From: (b)(6) .NAVFAC MIDLANT, ROICC Camp Lejeune
To: (b)(6) .NAVFAC MIDLANT, BD; (b)(6) .NAVFAC MIDLANT, ROICC Camp
(b)(6) .NAVFAC MIDLANT, ROICC Camp Lejeune; (b)(6) .NAVFAC
MIDLANT, Staff
Subject: Correspondence Regarding JT Yates Electric Service, Freedom of Information Act (FOIA) Request DON-NAVY-
2017-003161 - Camp Lejeune - P1383 & P1384 Base Entry Point / CLEO Building Projects Contract No. K1310-
002-S / Project Number K1310 SLO Case No. 16-970
Date: Friday, May 12, 2017 13:04:56
Attachments: [Non-DoD Source FW Rack Add at CLEO.msg](#)
[RE Rack Add at CLEO.msg](#)
[Non-DoD Source FW J.T. Yates Electric Service Inc. Group III Mgt. Inc. \(16-9704\).msg](#)
[Non-DoD Source FW RFP-063 CLEO LOCKERS AND ELECTRICAL CHANGES.msg](#)
[Non-DoD Source RFP-063 CLEO LOCKERS AND ELECTRICAL CHANGES.msg](#)
[RE ROADWAY LIGHTS ON AT WILSON GATE.msg](#)
[Non-DoD Source FW ROADWAY LIGHTS ON AT WILSON GATE.msg](#)
[Non-DoD Source Fwd ROADWAY LIGHTS ON AT WILSON GATE.msg](#)

Response to Request for Information - P1383/4 New Base Entry Road and Base Entry Point

DATE:	26 February 2016
FROM:	(b)(6)
SUBJECT:	RESPONSE MEMO: RFI No. 331
TO:	(b)(6) - OICC MCI East, MCB Camp Lejeune
COPY TO:	(b)(6) PE

CANOPY AREA UNDERGROUND CONDUIT AND WIRING
SCALE: NOT TO SCALE

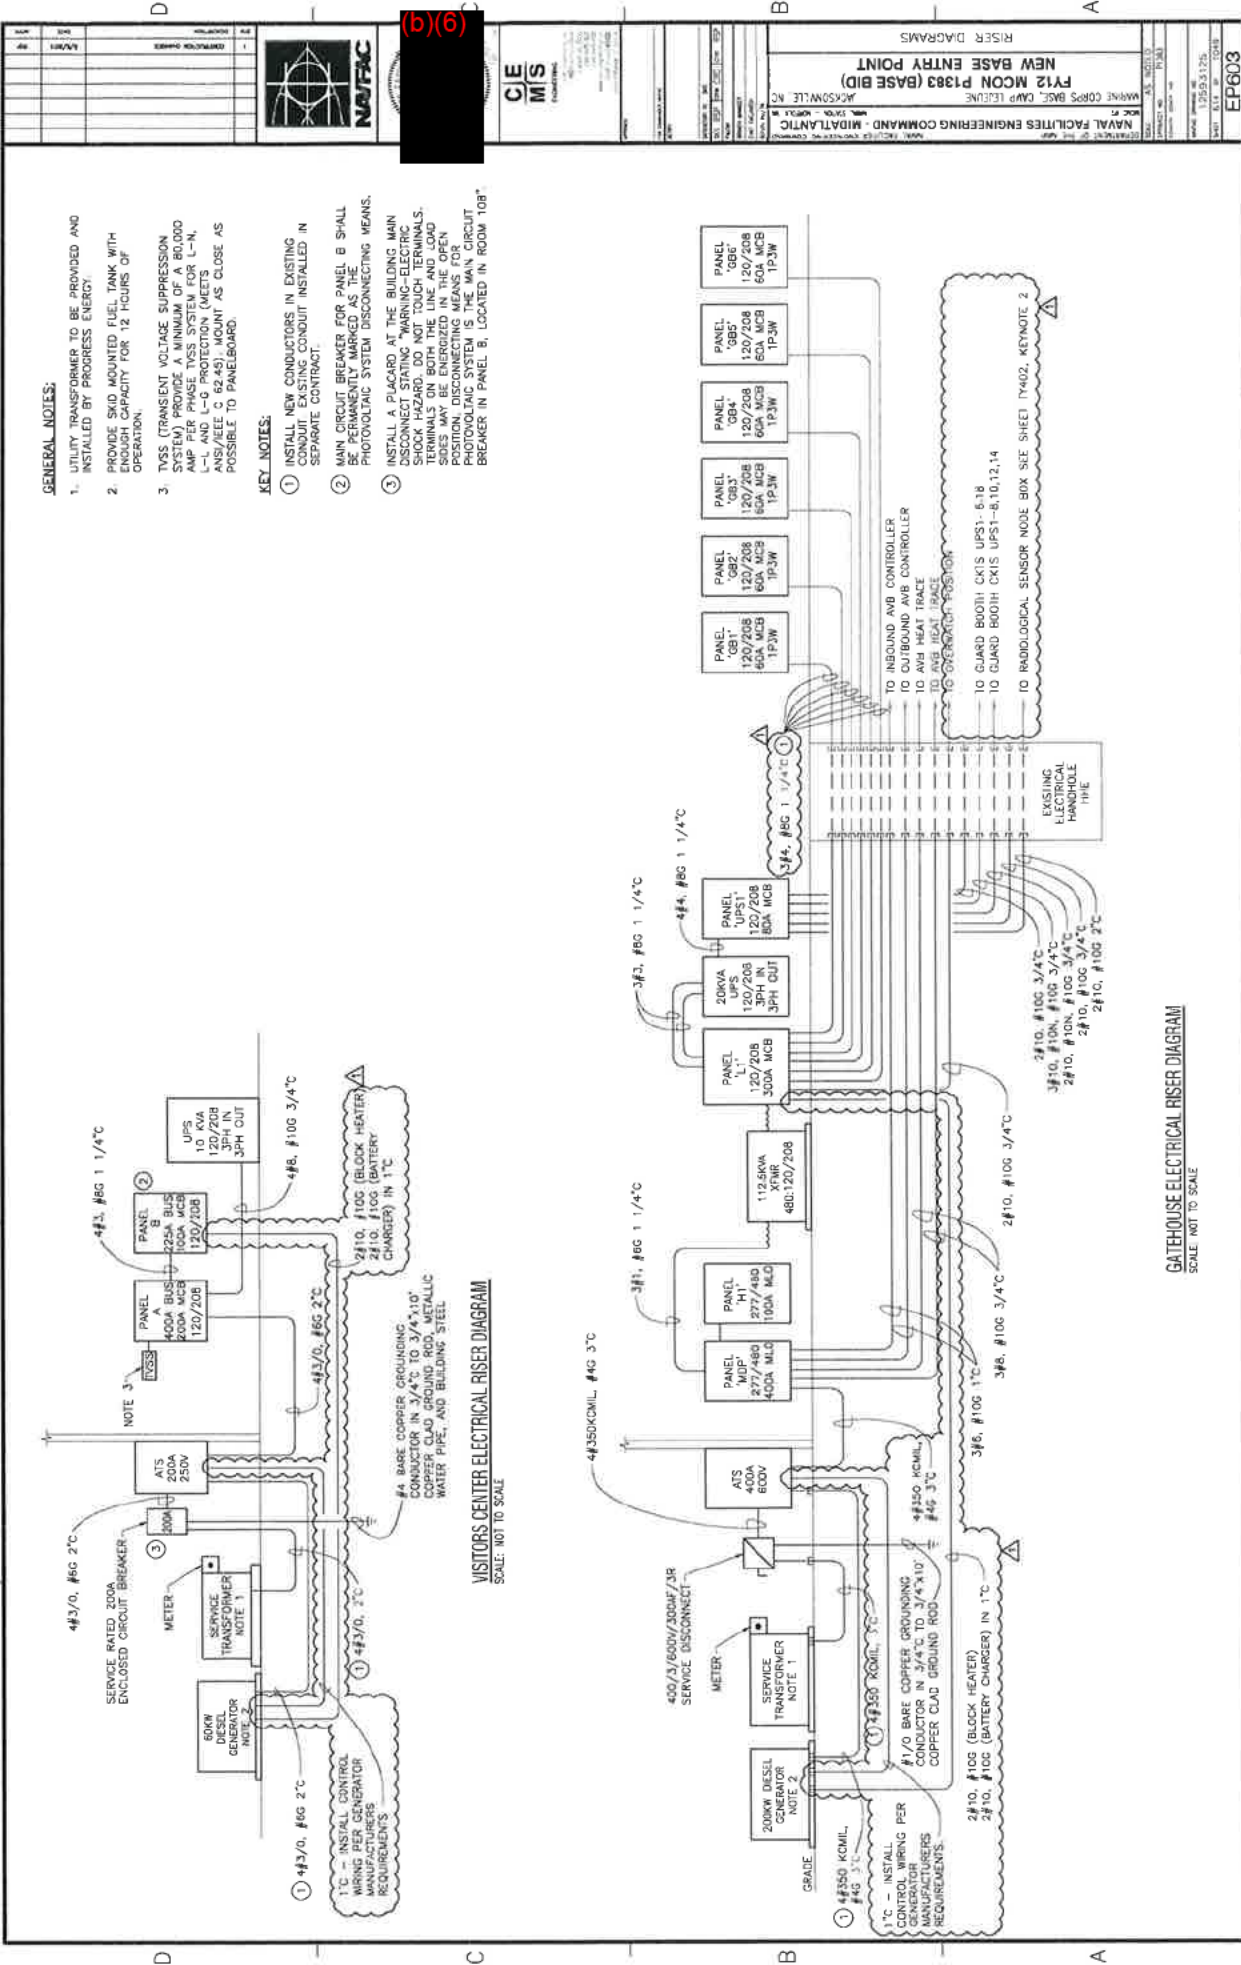
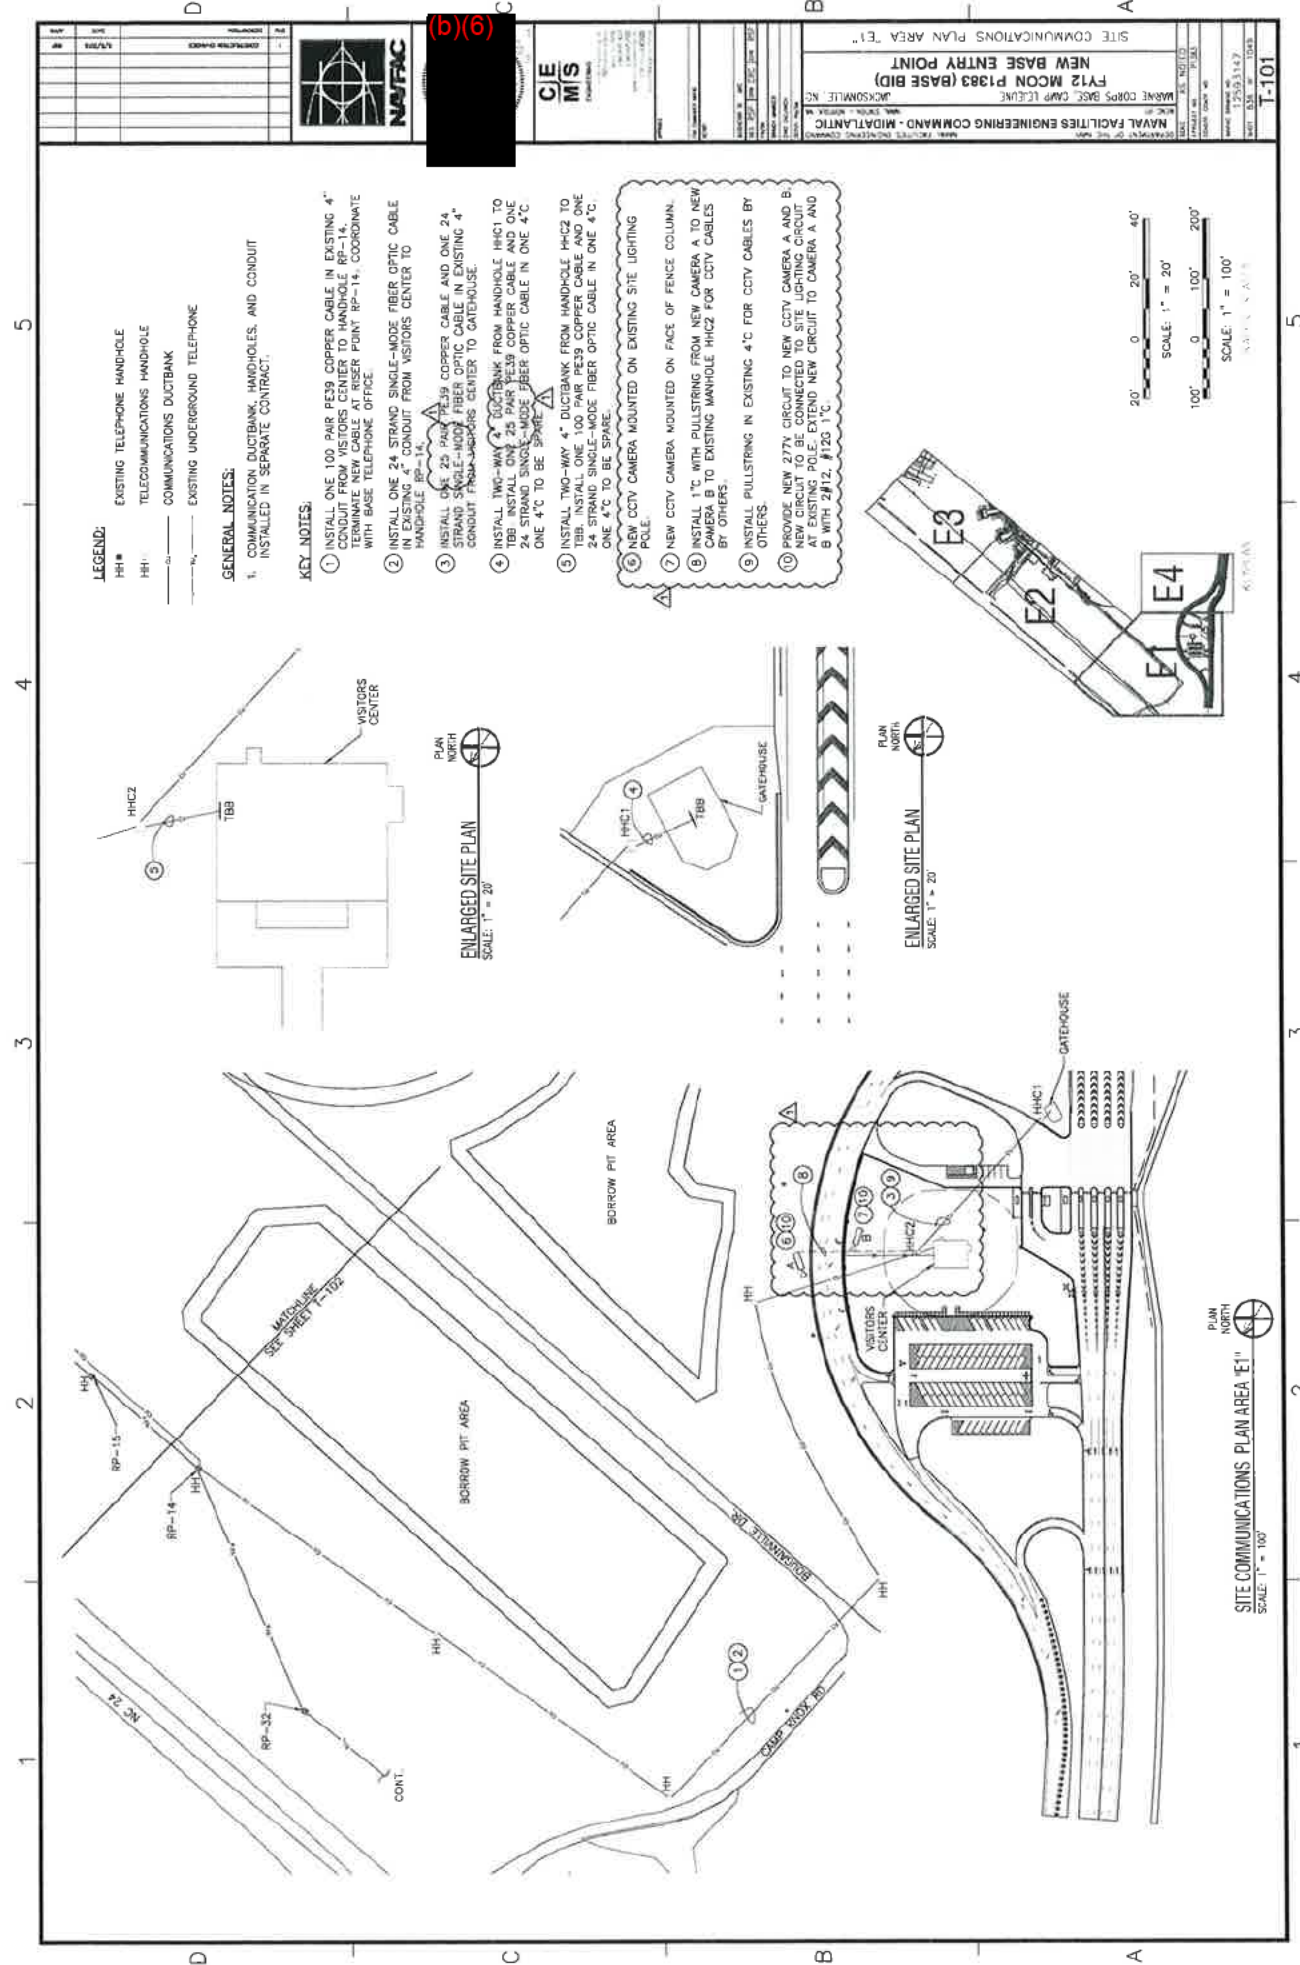
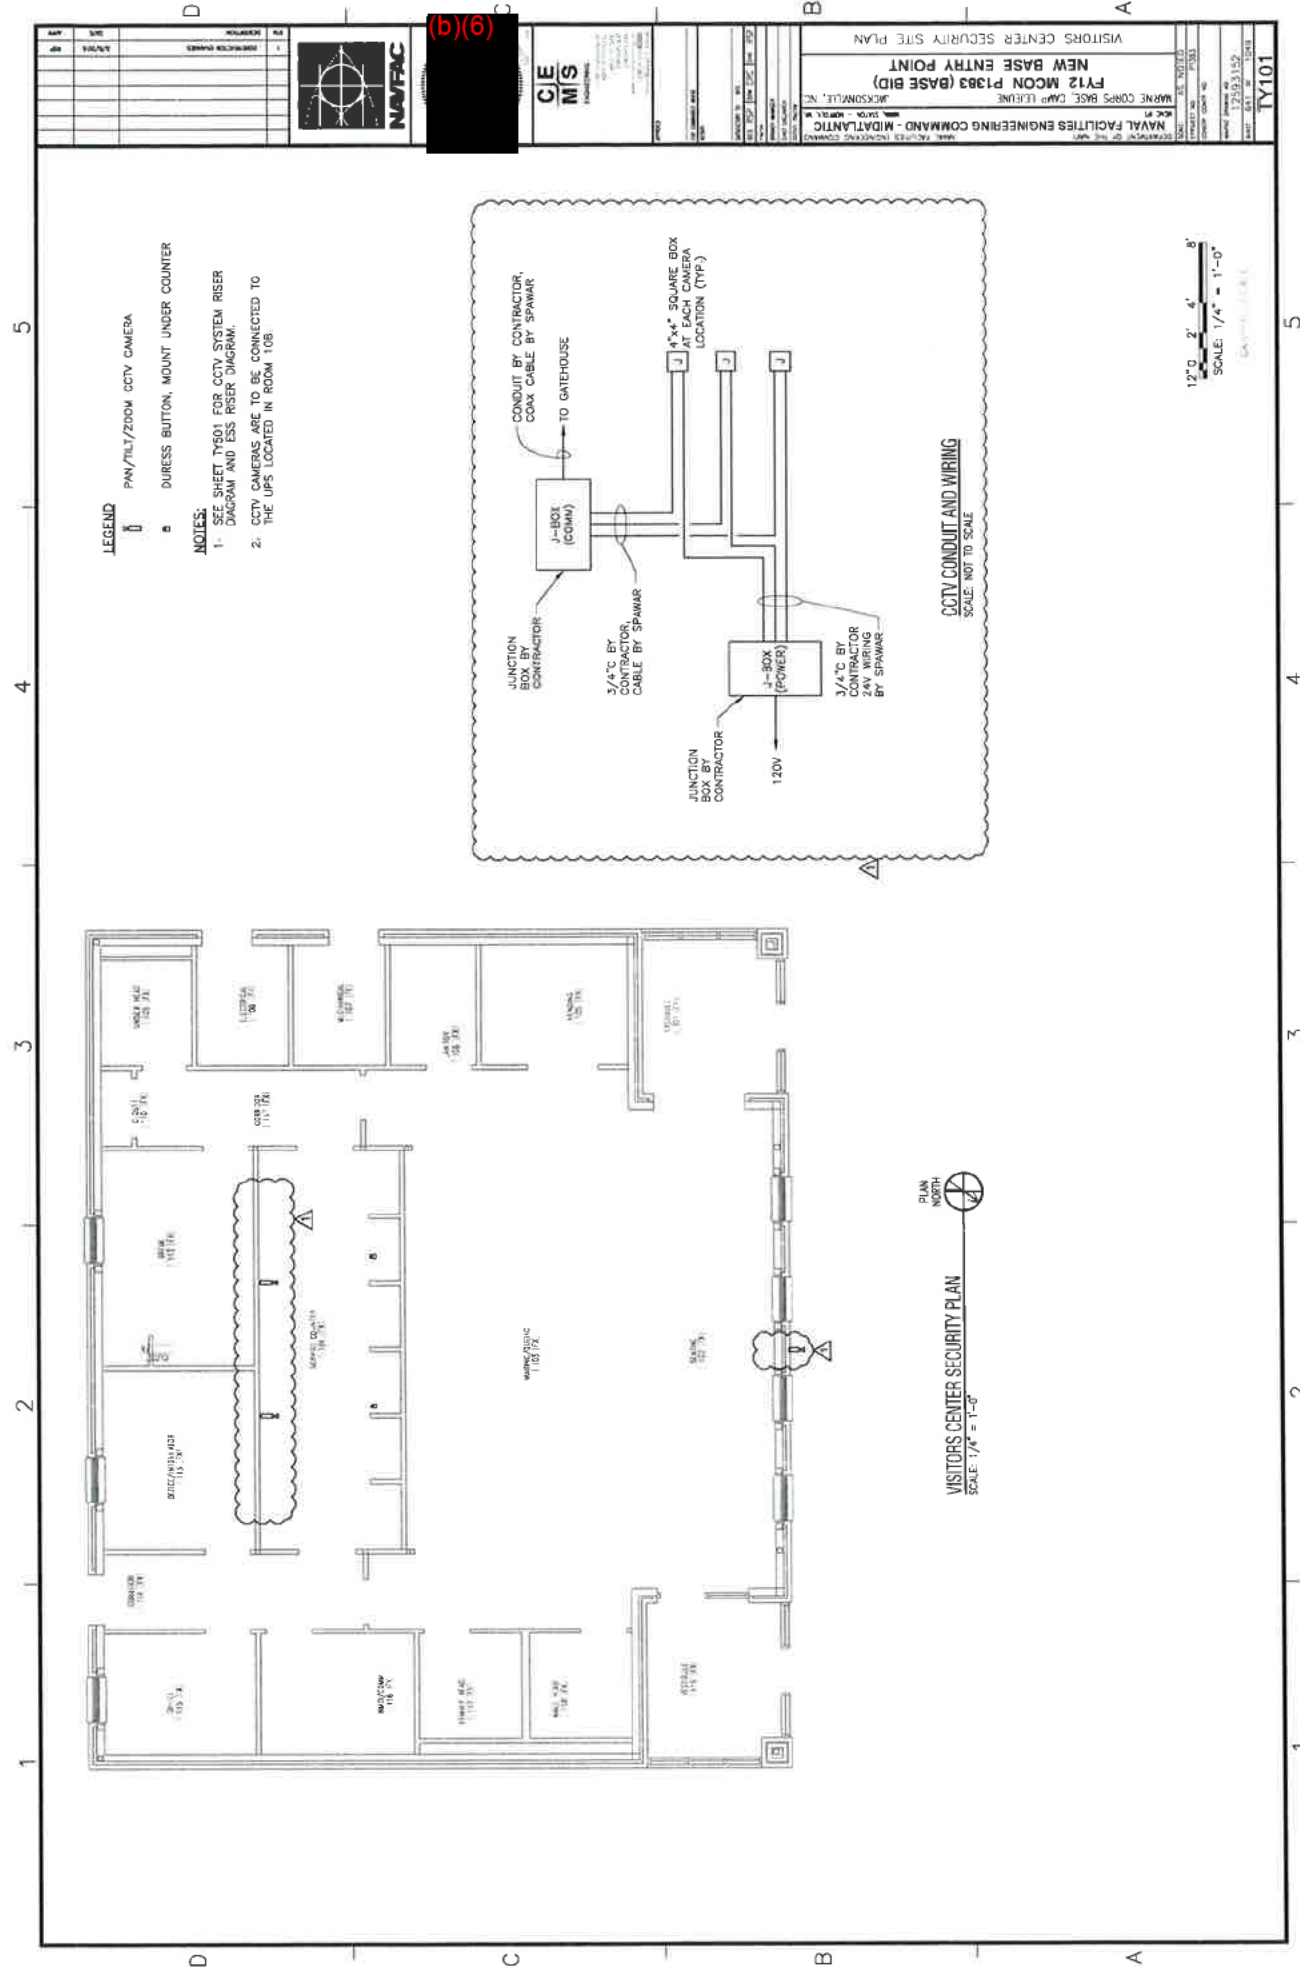
NOTES:
1. PROVIDE 1" WITH PULLSTRING FROM COLUMNS 1-5 NEMA
BOXES TO COLUMN 8-12 JUNCTION BOXES FOR CCTV CABLES.
